Advanced Micro Devices Inc. 1 Commerce Valley Drive East Markham, Ontario			
Date: Wednesday, December 09, 2009		Rev 01	
Sheet 1 of 21		Doc No. 105-C012xx-00E

Title **BH-11UNIPER LE GDDR5 1GB DP+DP/HDMI+2xDVI**

REVISION HISTORY

(19) Debug Circuits

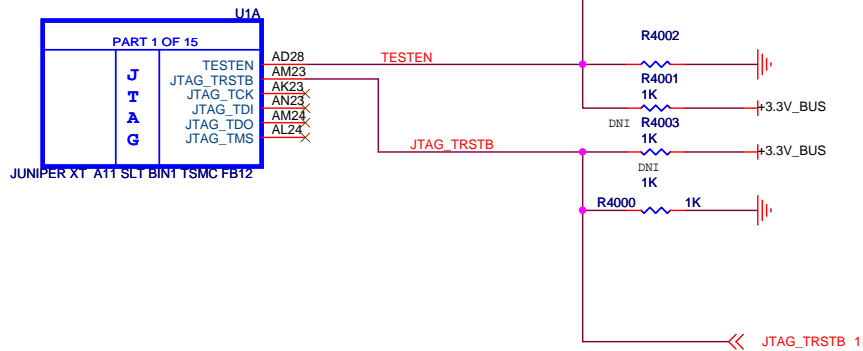
- 1.Remove LED RED "ON" shows Fault circuit
- 2.Remove JTAG and re-connect to PCIe RESET Buffered
- 3.Remove SWITCH CONNECTIONS TO PINSTRAPS
- 4.Remove LM96163
